REGULATORY HEARING REPORT

To: The Hearing Commissioners
From: Mark Batchelor (Consultant planner on behalf of Waipa District Council)
Subject: Subdivision to create 246 Residential Lots within the C2 Growth Cell, and associated lots for public assets.
Hearing Date: 26 and 27th May 2021
File Reference: SP/0179/20

APPLICANT:	3MS Of Cambridge Limited Partnership
PROPERTY ADDRESS:	1865, 1863, 1871, 1881 Cambridge Road, Cambridge,
LEGAL DESCRIPTION:	Lot 2 DP 29023, Lot 1 DPS 75243 and Lot 1 DPS 31006, Pt Lot 1 DP 29023, Lot 1 DPS 85575, Lot 2 DPS 85575
SITE AREA:	40.8416ha
ZONING – DISTRICT PLAN:	Deferred Zone / C2 Structure Plan
PROPOSAL:	Subdivision to create 262 lots including 246 residential lots and 16 lots for future subdivision for residential, commercial and various public assets within the C2 Growth Cell.
APPLICANTS CONSULTANT	Mitchell Daysh Limited

FIGURE 4: COMPARISON OF C2 AND APPLICATION STRUCTURE PLANS

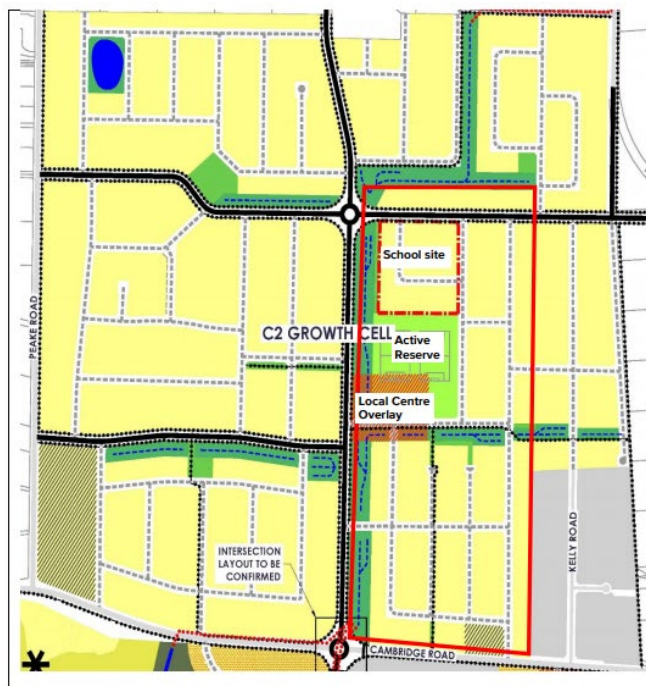
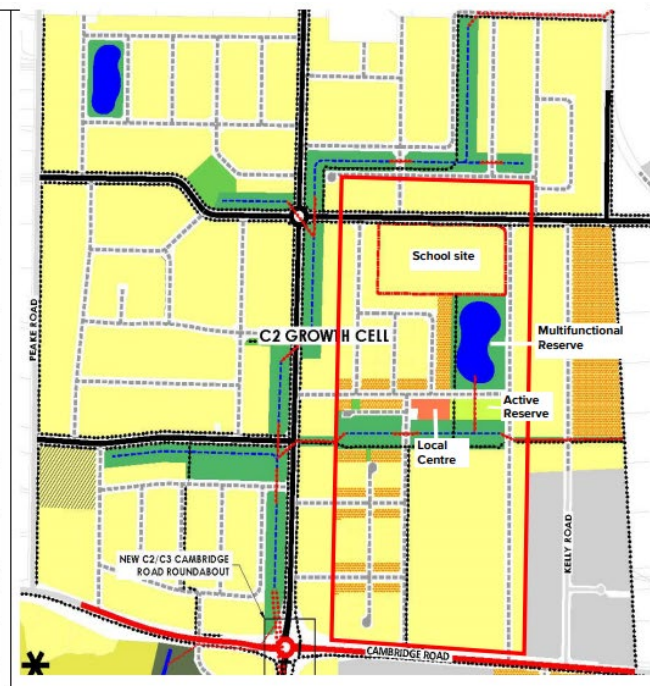
3.10 **Differences between the C2 structure plan and application structure plan** proposed in the application are summarised below.

- i. Variations in location and shape of the school site.
- ii. The sports field is removed. Negotiations between the Council and applicant have reached a stage where replacement of the sports fields to their original location planned in the C2 structure plan has been suggested and sale and purchase negotiations have been initiated (refer above to paragraph 2.15).

- iii. The local community/commercial centre is reduced in size and relocated towards the east to a location more central to the application site rather than a location central to the wider C2 structure plan. This separates the community centre from the collector roading that contribute to this separation by being moved west onto adjacent land, within the C2 structure plan.

- iv. Introduction of higher density (compact) housing areas.
- v. Variations in roading layout from the C2 structure plan including variations in connections with adjacent land within the C2 structure plan.

FIGURE 5: AMENDED APPLICATION STRUCTURE PLAN – INCLUDING CONNECTION TO KELLY ROAD LOCALITY

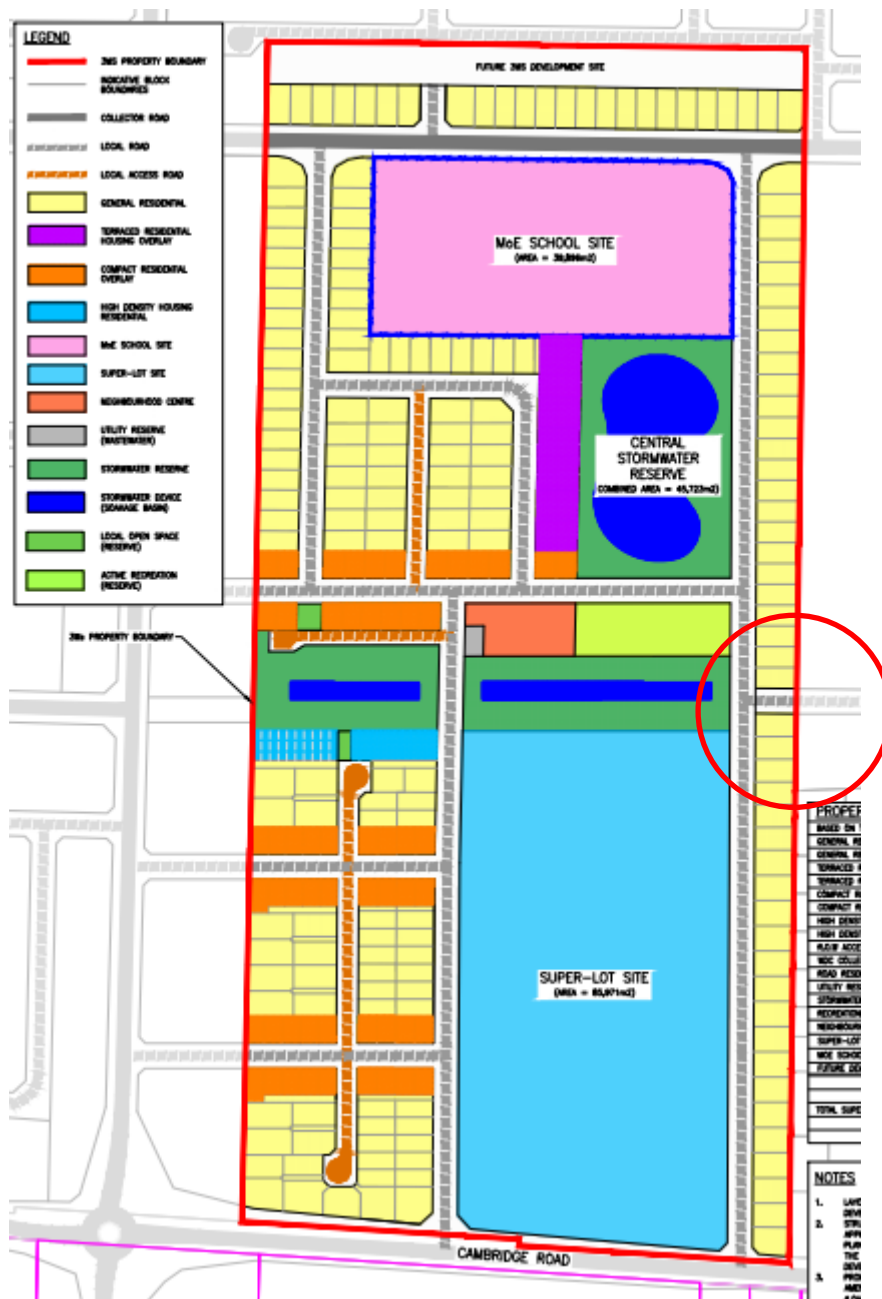
- 3.13 **A revised structure plan** has been lodged subsequent to requests for further information, the applicant has provided this on the 10th March 2021. This is provided in Appendix 3.
- 3.14 **Replacement of the Kelly Road link** referred to in paragraph 3.12 above is shown in the attached replacement scheme plan as a Lot 500 as drainage and road reserve.
- 3.15 That link is provided as a lot for acquisition rather than a local road to be vested as shown in the C2 structure plan.
- 3.16 An extract of the proposed (application) structure plan is provided below as Figure 5. The Kelly Road connection is shown within the red circle.

- 5.4 The link road between the application site and the Kelly Road locality was also returned to the proposal (refer to Appendix 3).
- 5.5 Replacement of the link road to the Kelly Road locality is reported above in paragraphs 3.14 and 3.15 and shown by the red circle on Figure 5.

FIGURE 6: REINSTATED SPORTS FIELDS LOCATION – STILL UNDER NEGOTIATION

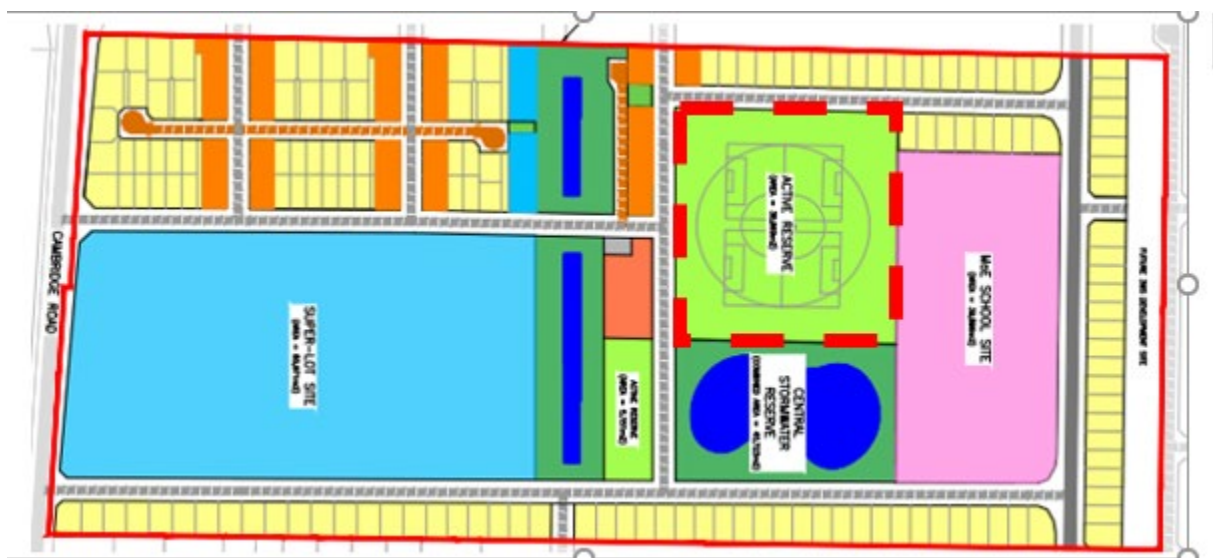
7.3.4 At the date of this report, the plan provided as Figure 6 has been received. This shows the location the sports fields being discussed with the applicant. Confirmation of this as being proposed as an amendment to the application is however still required. This location is similar to where the sports fields were removed from in the application. This would resolve structure plan issues in this regard.

- 9.4.6 Removal of the sports fields, which is continuing to be negotiated with the applicant, and return of these to either the site or alternative location within the C2 structure plan or alternatively close by to achieve a relatively central location and accessibility as indicated in the amended plan provided as Figure 6 would resolve this matter.
